Submission to Planning Authority Notice

Planning Department
Northern Midlands Council

PROJECT SHED EXTENSION 2 HUGHES CRT WESTERN JUNCTION TAS 7212	DATE 4/08/2023	SCALE As shown @ A3	DRAWING TITLE PROJECT INTRODUCTION	NORTH
CLIENT BINC HOLDINGS	CONTACT Email: laura@wilkindesign.com.au Phone: 0432 928 361 PO BOX 478 LAUNCESTON, TAS. 7250		DRAWING DA02	
ACCREDITATION NO. CC678X

Appendix A – 3 Hughes Court – Detention Longsection – Peak Level

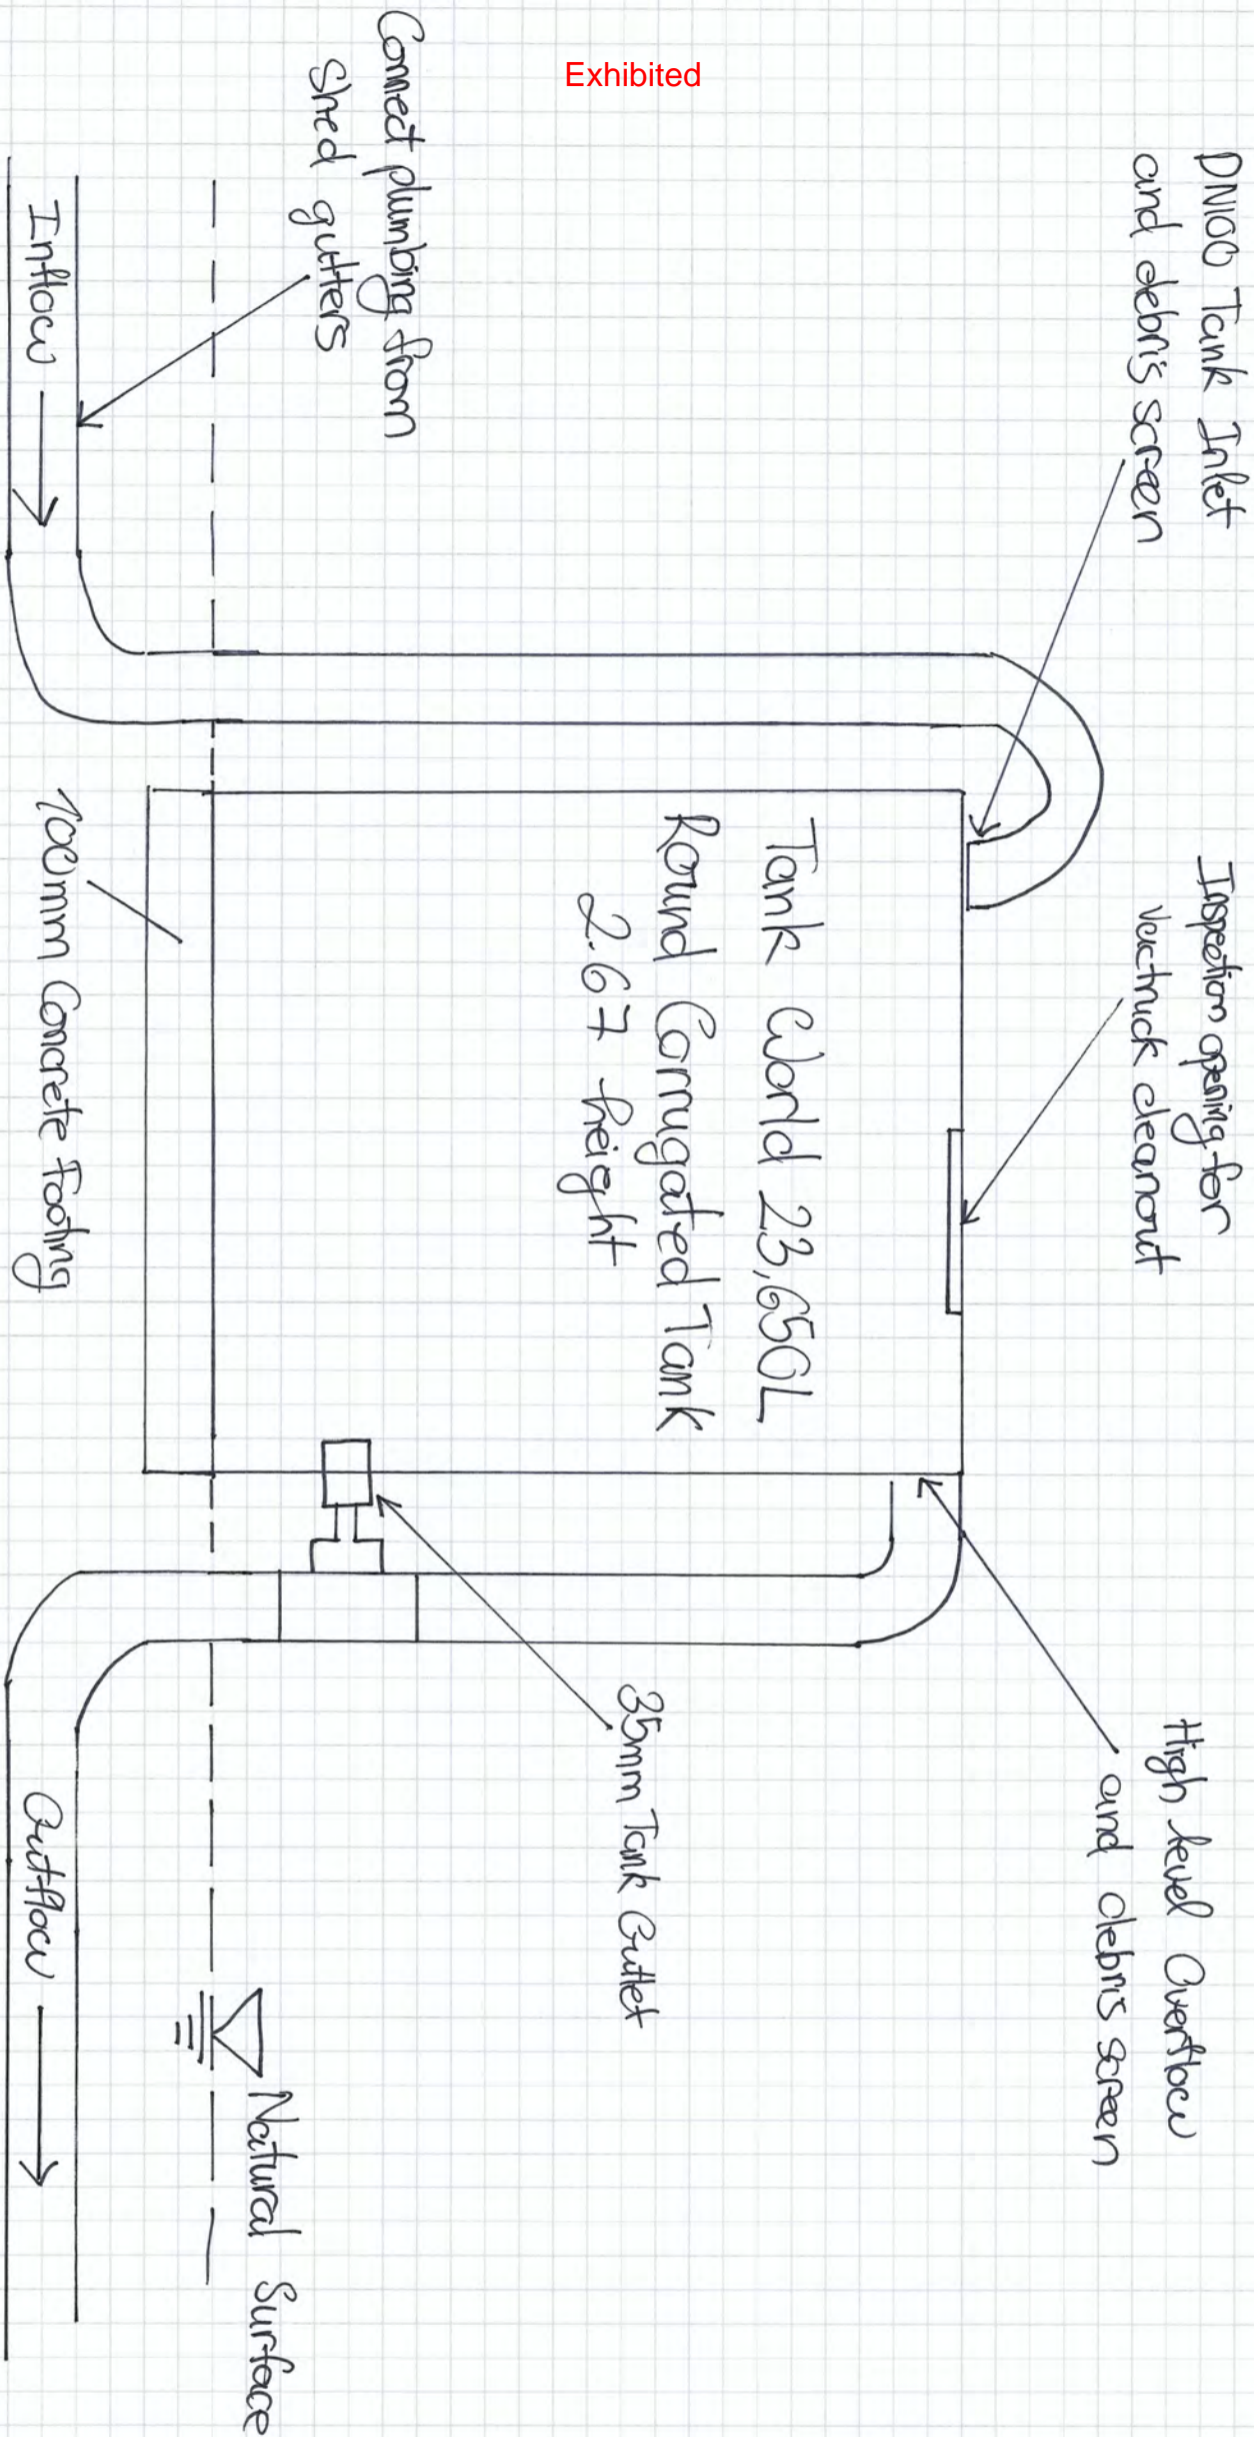
Note: Outlet pipe 1.1 representing council's infrastructure has been raised 300mm to provide outlet control, as discussed with Council's stormwater engineer.

PROJECT	DATE	SCALE	DRAWING TITLE	NORTH
SHED EXTENSION 2 HUGHES CRT WESTERN JUNCTION TAS 7212	4/08/2023	As shown @ A3 1:400	SITE PLAN	
CLIENT	CONTACT		DRAWING	
BINC HOLDINGS	Email: laura@wilkindesign.com.au		DA03	
ACCREDITATION NO.	Phone: 0432 928 361			
CC678X	PO BOX 478 LAUNCESTON, TAS. 7250

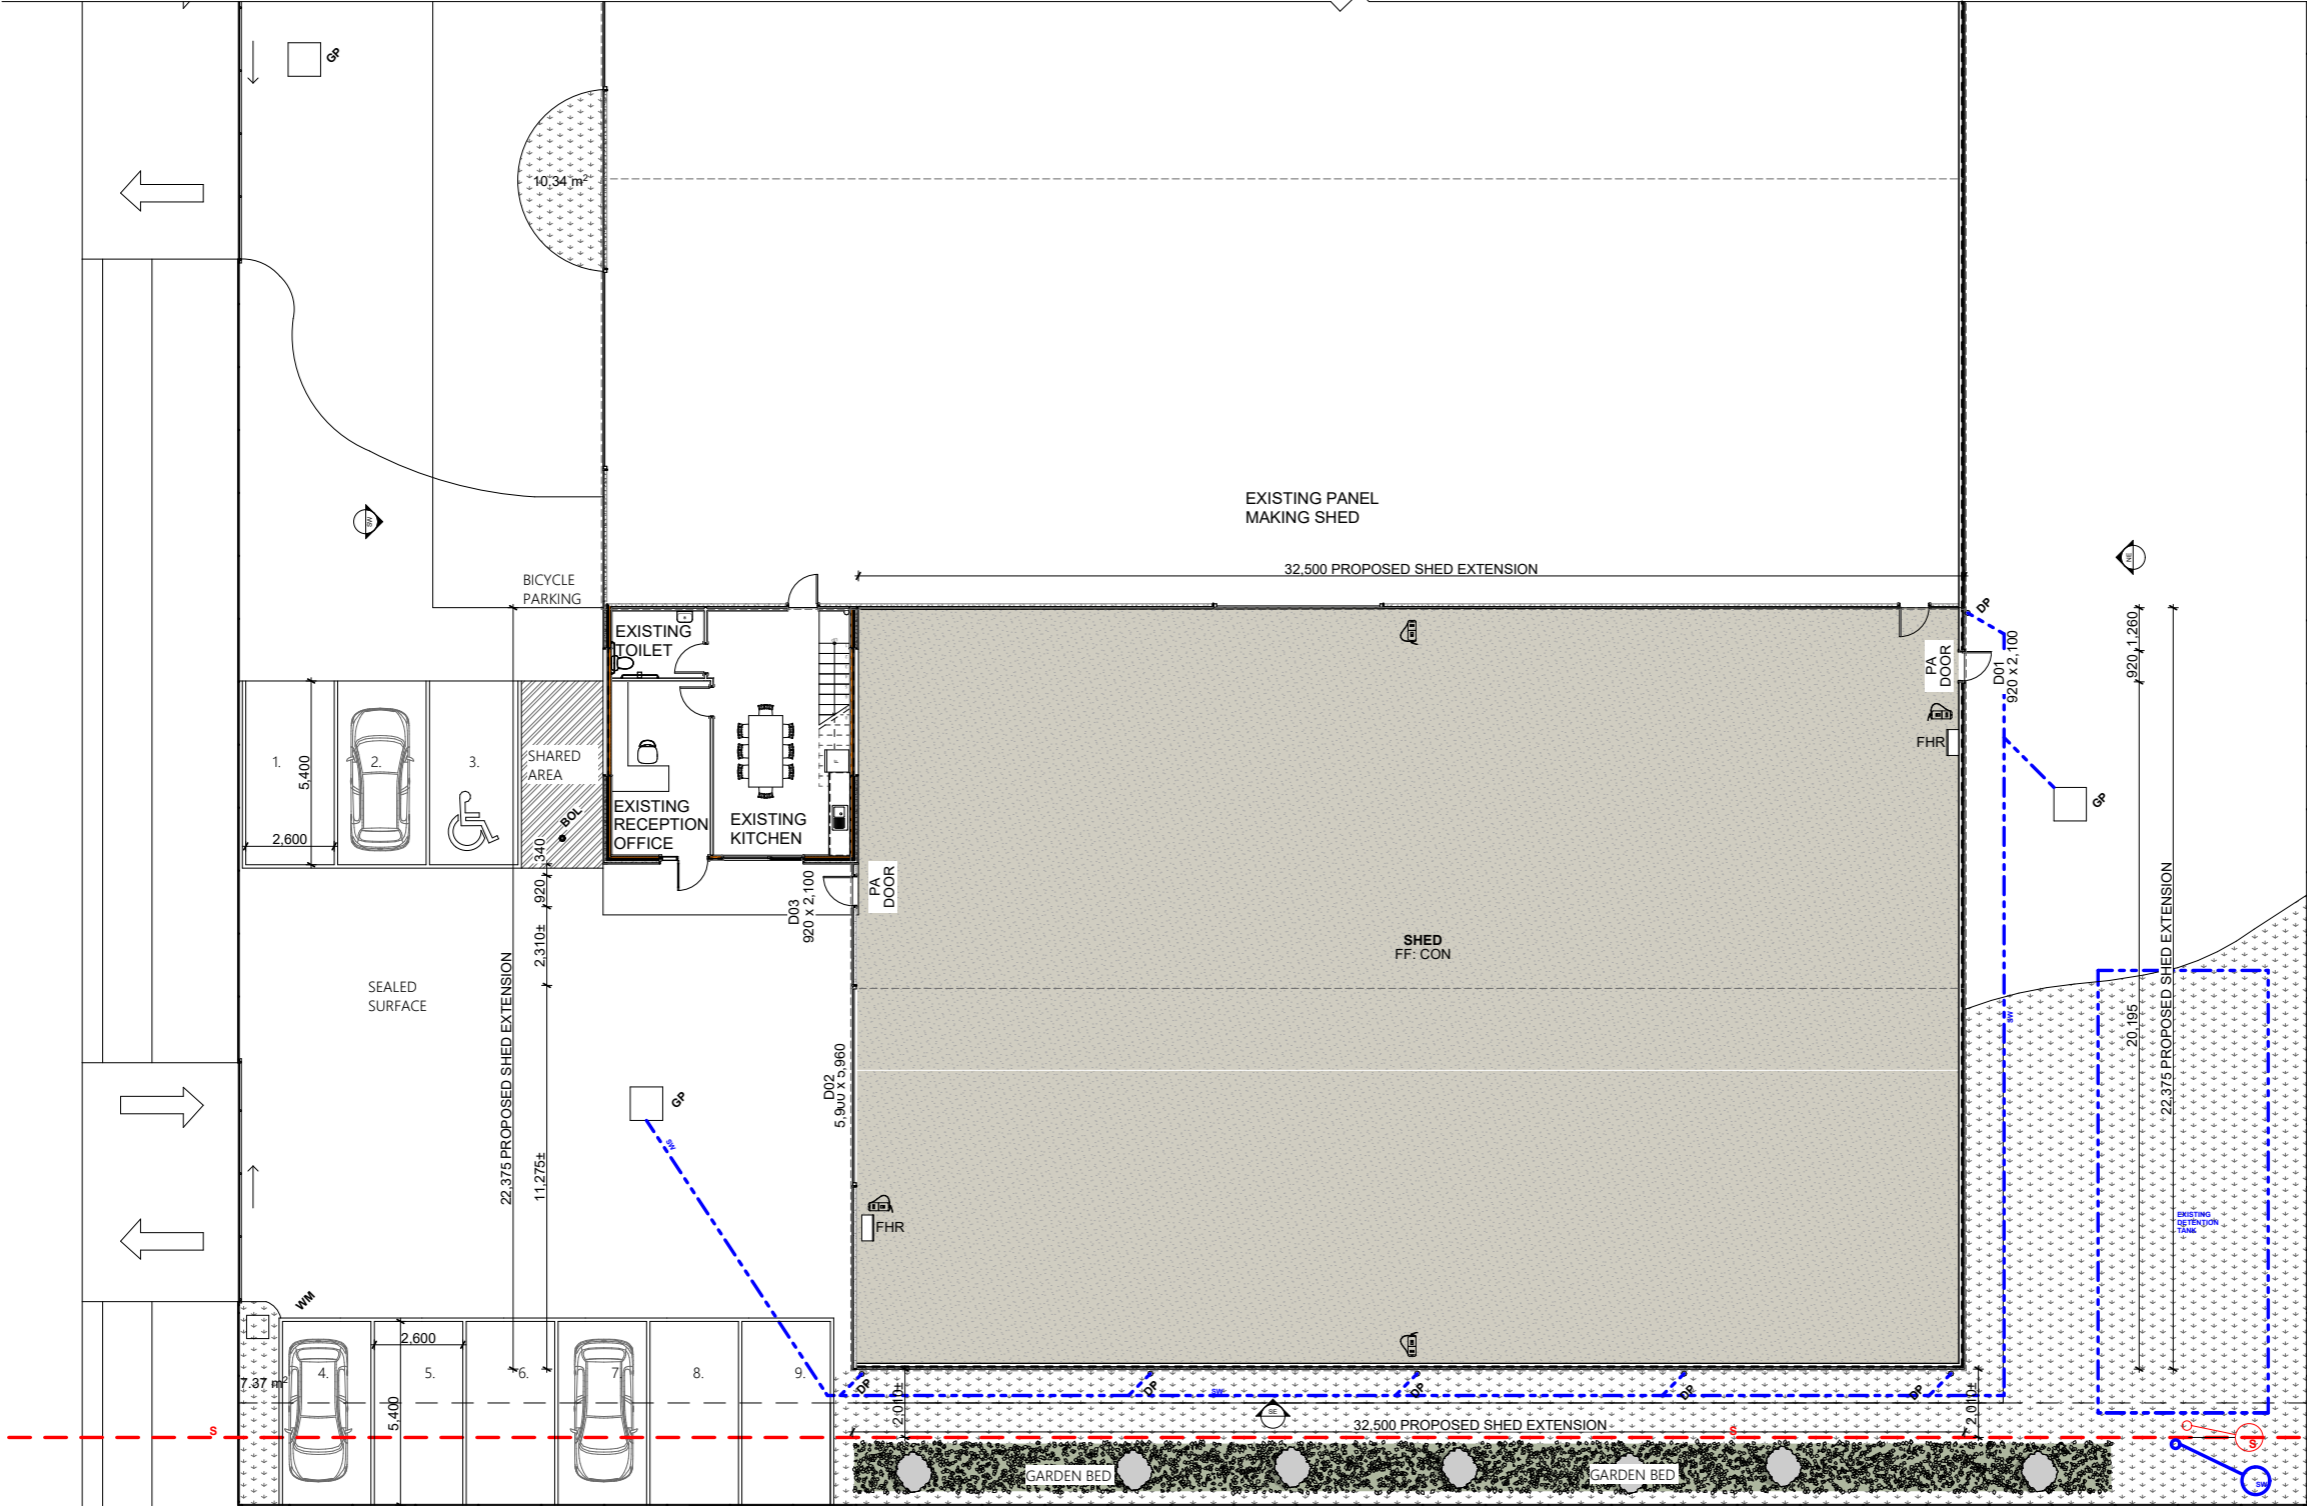
- 1. Provide amended plans to demonstrate the offset of the proposed development to the sewer main, if less than 2m a referral will be undertaken to TasWater.***

- i) Provide a revised onsite stormwater management plan and design drawings in accordance with the Translink Special Area requirements of the planning scheme.***
- ii) Please provide details of the location of the onsite detention tank and confirm that it is not located under the proposed shed extension.***

Please refer to amended plans with dimensions added for the offset between sewer main and the south-eastern wall of the proposed development.

Please refer to the drawings for the location of the existing detention tank. Plans confirm that it is not located under the proposed shed.
